Certificate of Appropriateness

City of Milwaukee, owner
2808 W. WELLS ST., Concordia Historic District

PTS ID 73049 COA, FRONT, SIDE AND REAR PORCHES; SIDING REPAIR

2808 W. WELLS STREET

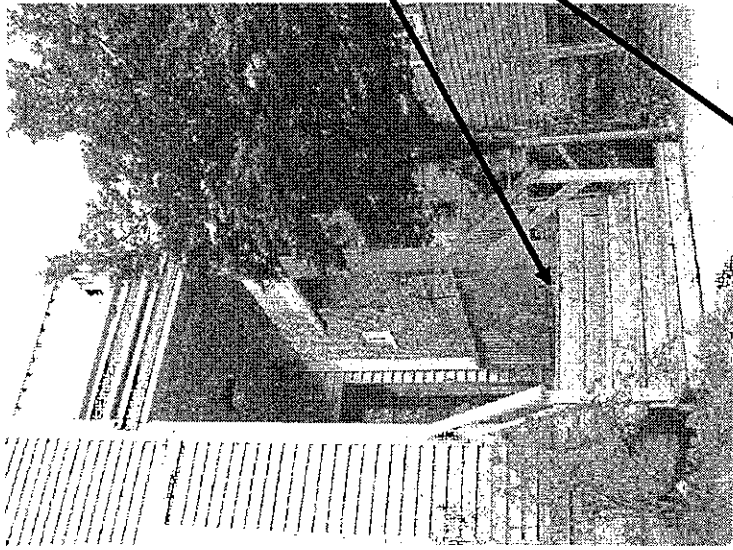
Front porch deck and railings to be replaced.

10. Side porch (North Elevation)

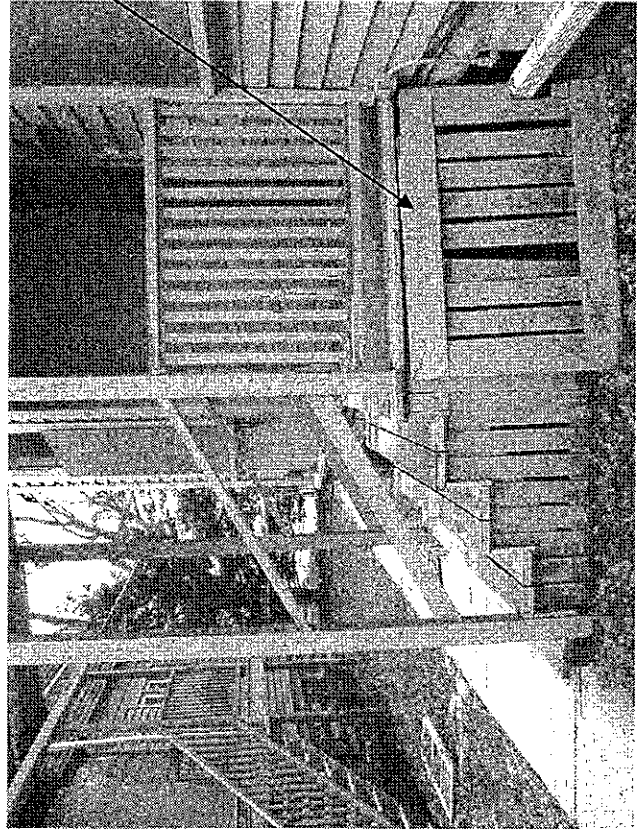
Side porch roof and stoop to be removed and replaced with a new wood stoop only. Stoop can be finished with decking boards that are gapped 1/8" for water drainage because there will not be a roof over it.

11. Front side window (South-West Elevation) with missing Stool and Apron

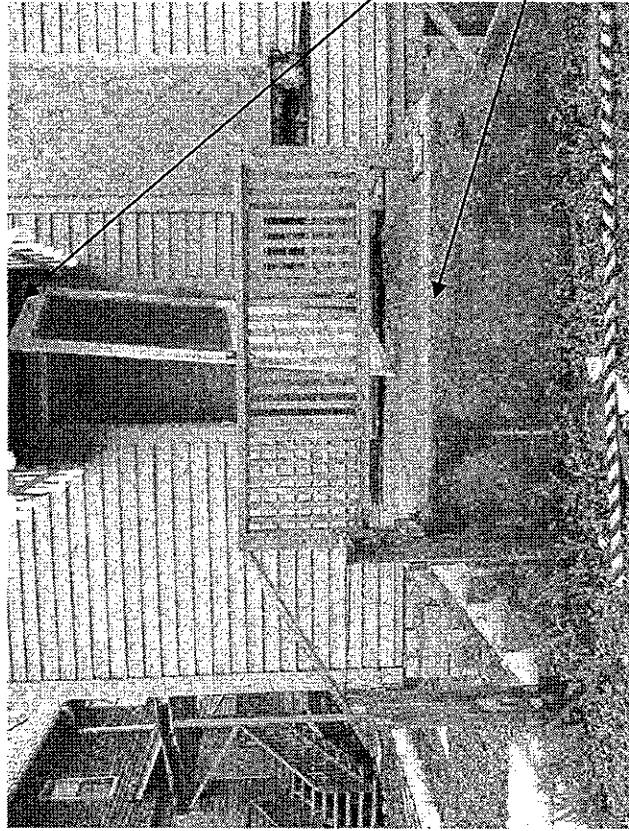
Replace missing trim to match original. Thickness and profile of new wood must match the original.

REAR PORCH 2808 W. WELLS (EAST ELEVATION)
SCALE: 1" = 1'-0"

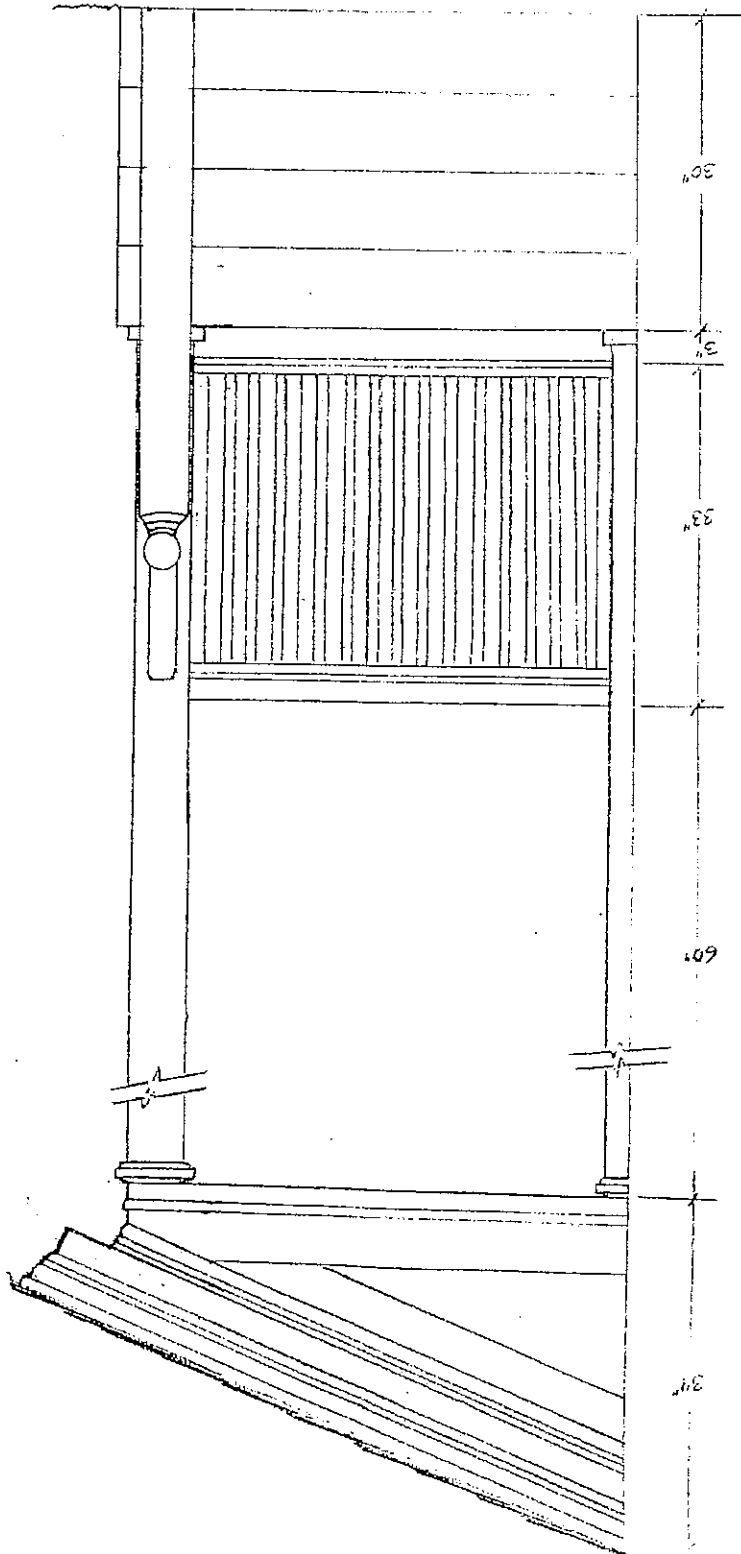
Elevation of new rear porch

TYPICAL CAPITAL DESIGN

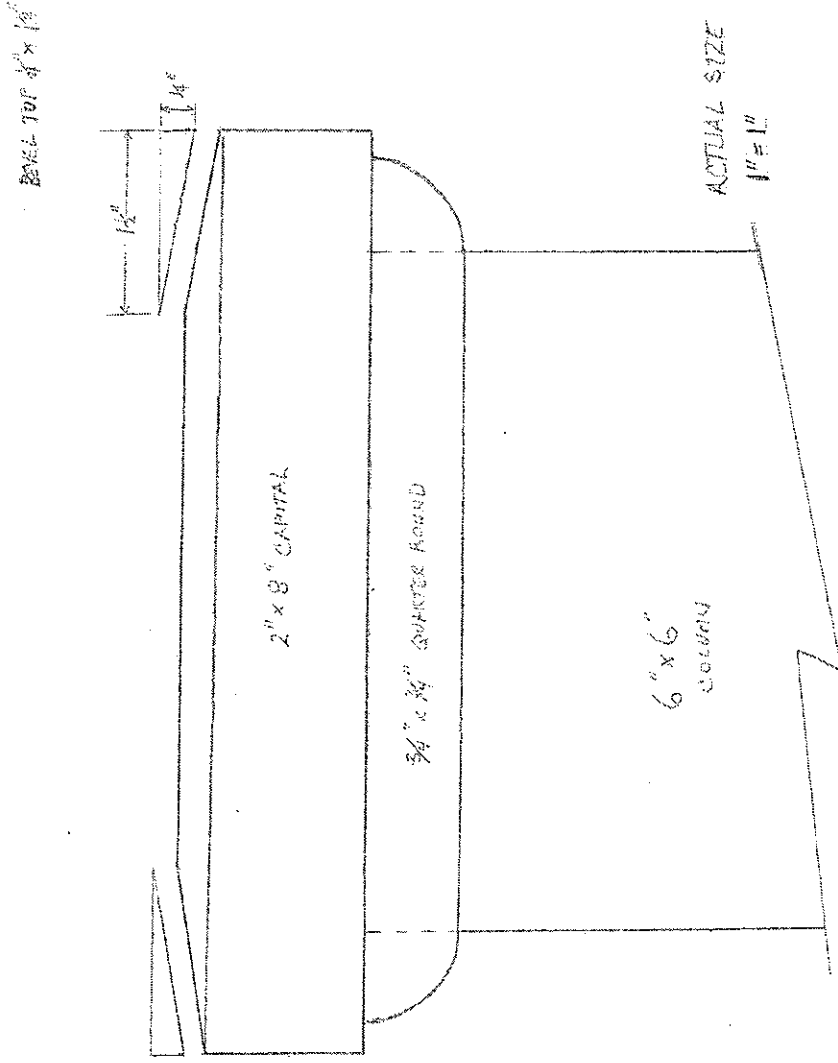
Detail of column capital for rear porch

TYPICAL EAVE DETAIL

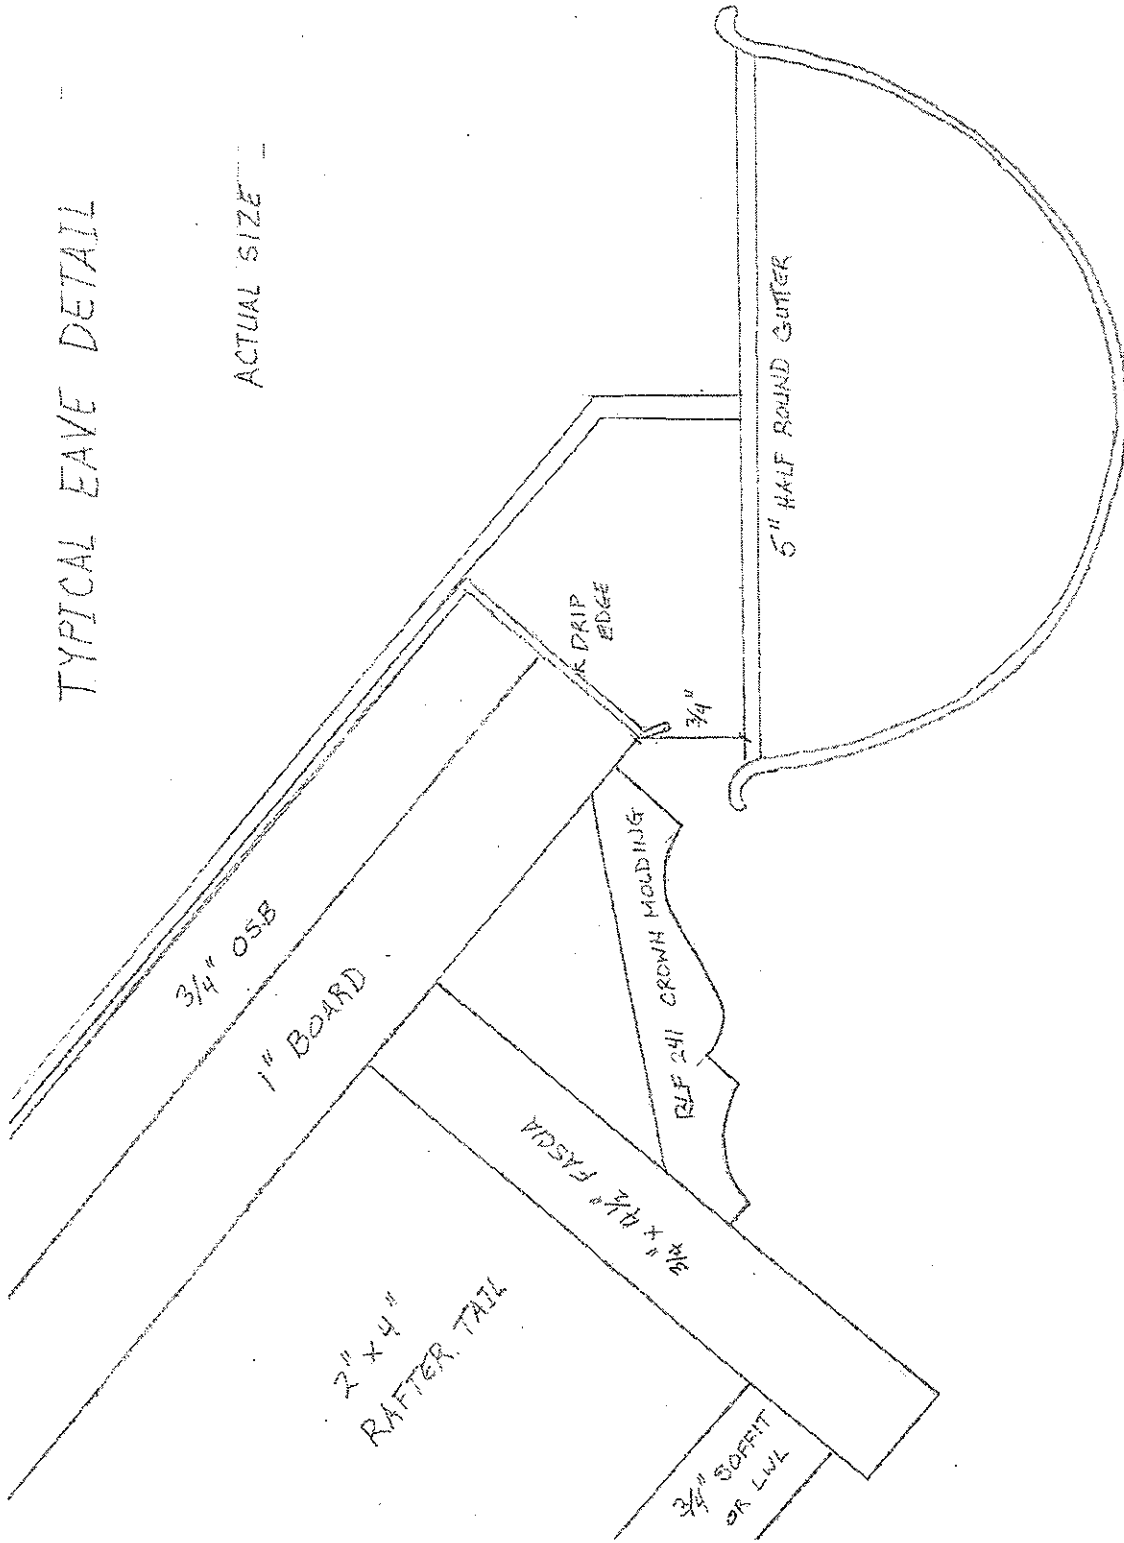
Detail of roof for rear porch

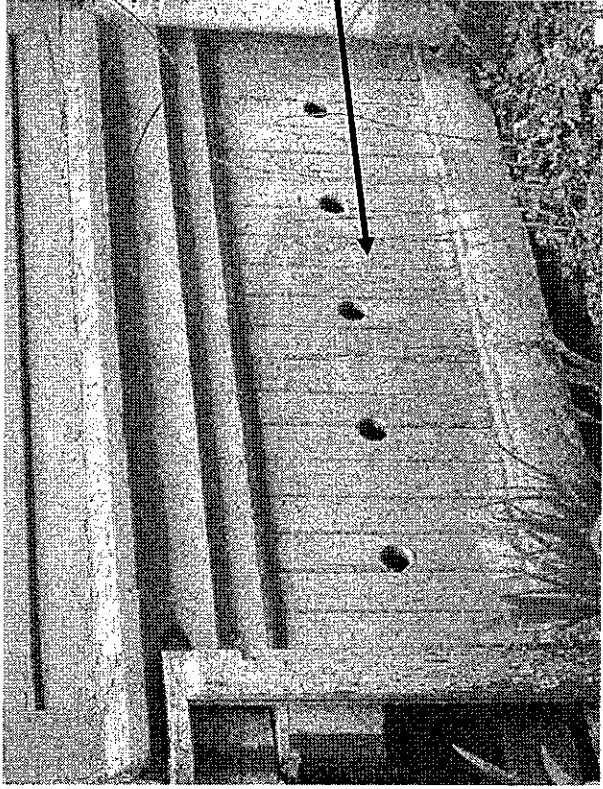
Detail of skirting that will be installed on front, side and rear porches.

6. Missing Water Table board and drip edge at foundation sill plate

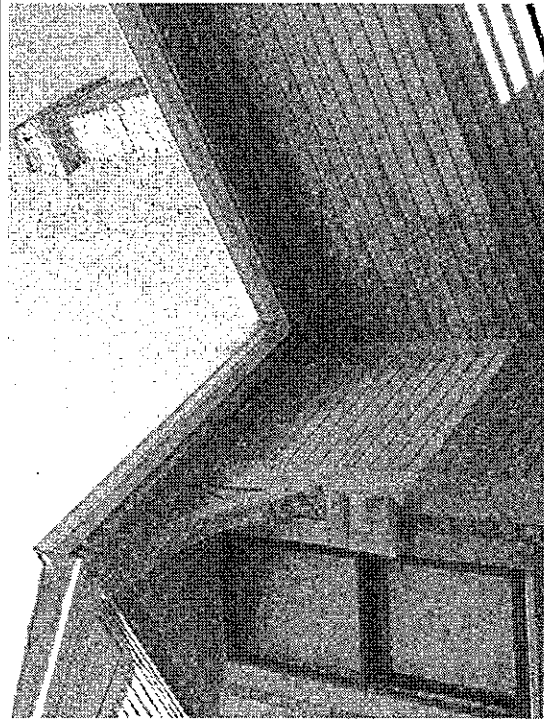
Replace missing and damaged water table boards to match originals

7. Second floor (North-East Elevation) above side porch

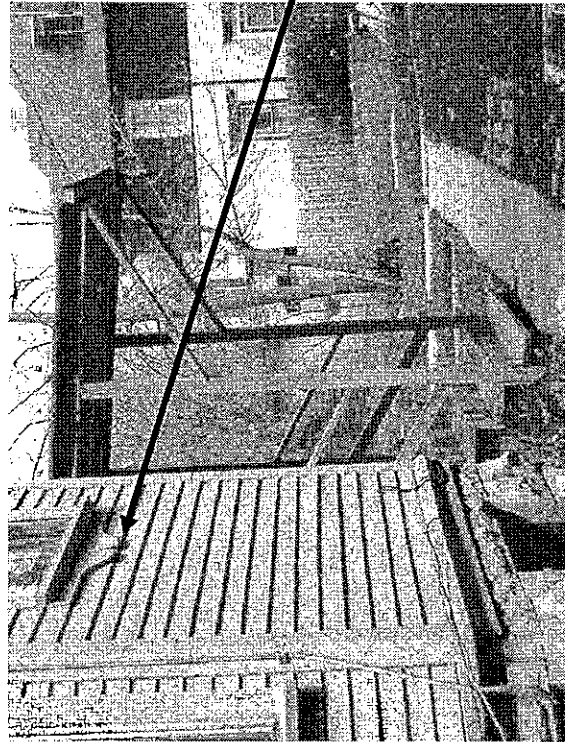
Missing trim under windows to be replaced according to this original design

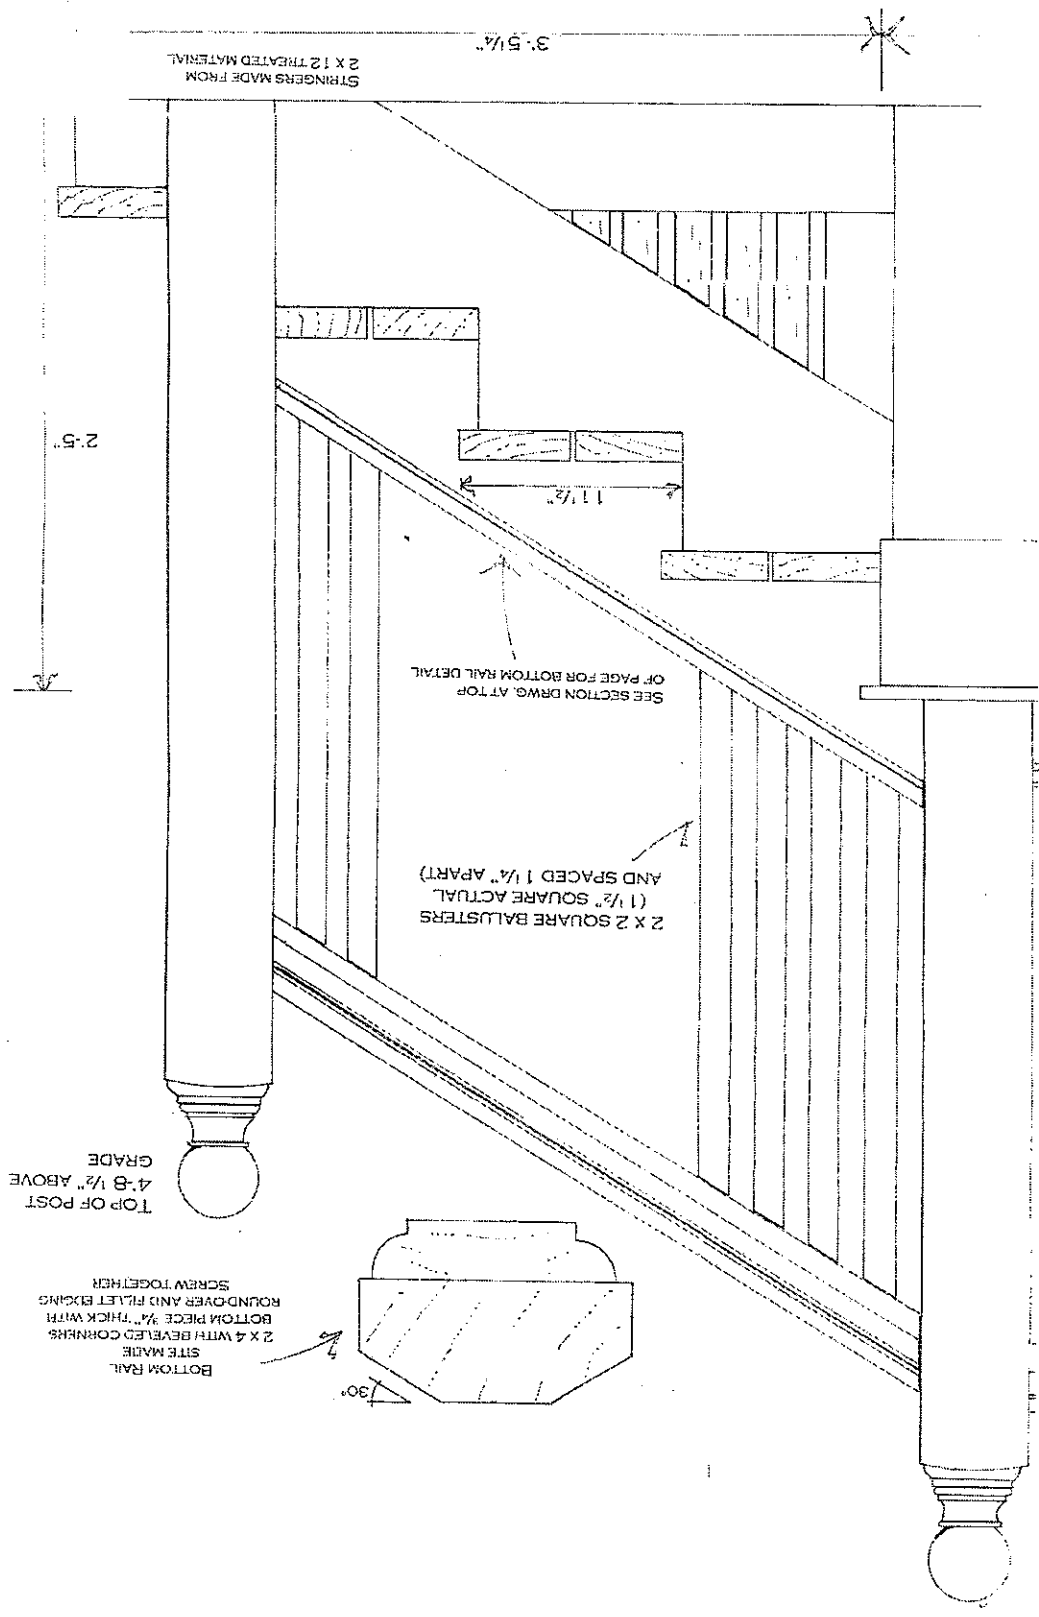
Front and rear porch deck to be rebuilt according to this design and configuration

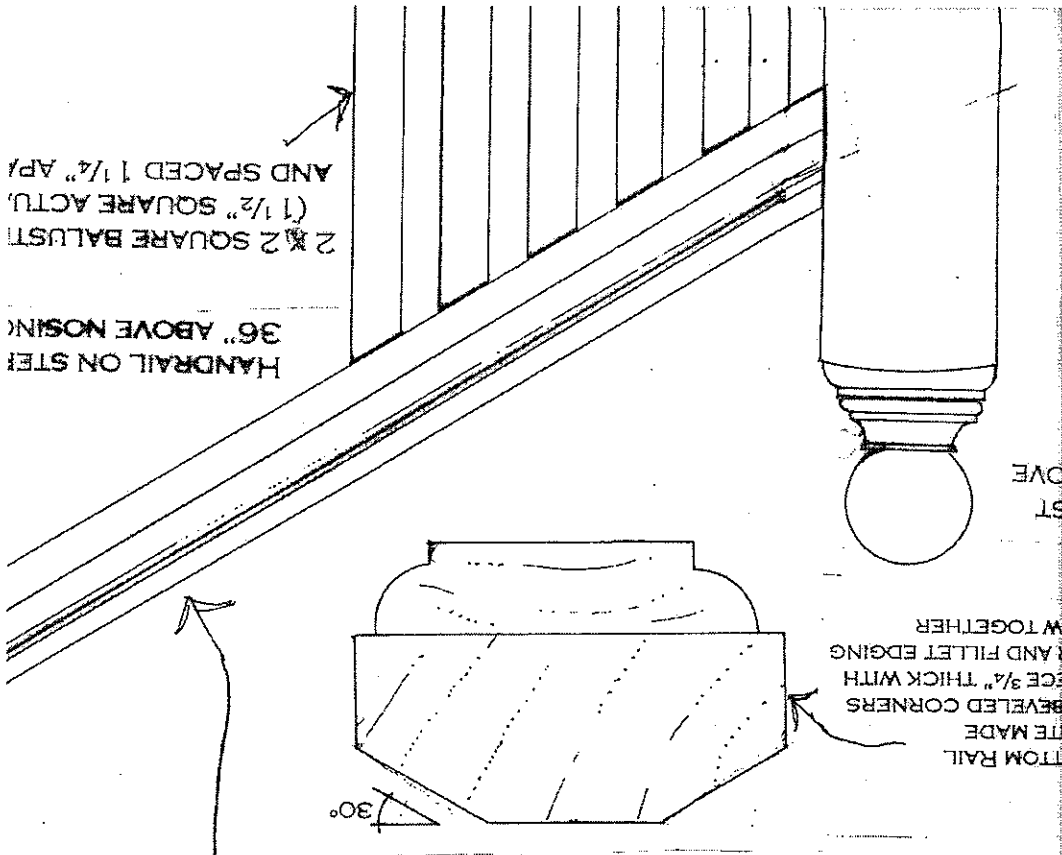
Detail of railings and newels for all three porches

GRASPABLE HANDRAIL
CROWN SPECIALTY MOULD
#HR-548
WWW.CROWN.SPECIALTY.MOULD
608-290-1338
MILTON, WI

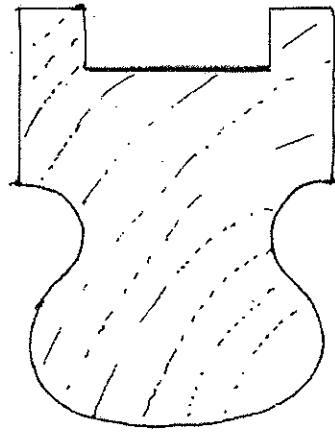
Detail of handrail and bottom rail for all three porches

Porch Skirting

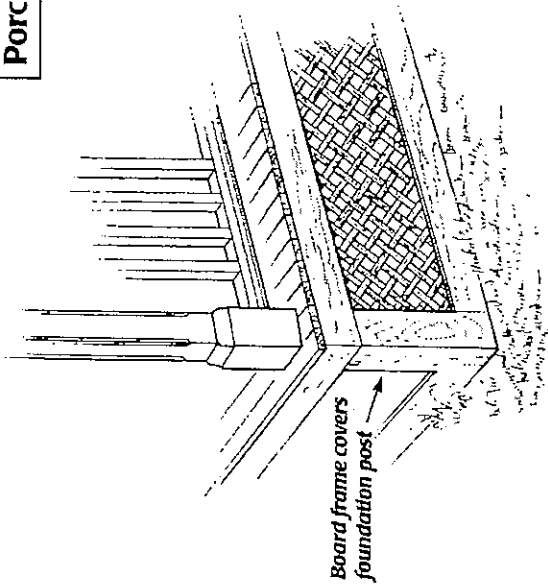
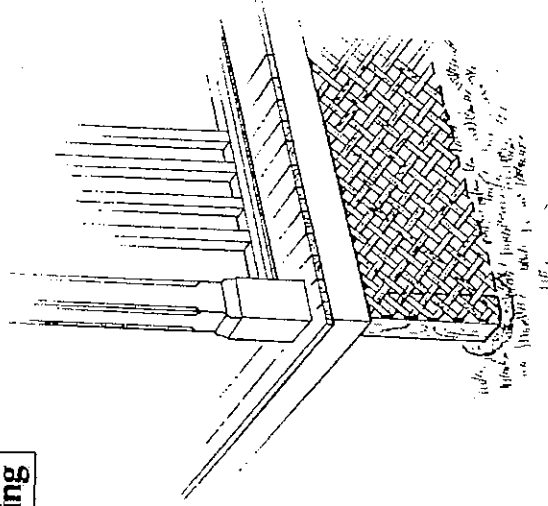
Porch skirting must be completely framed on all four sides. The lattice infill will be omitted in favor of the board skirting pictured above in this COA.
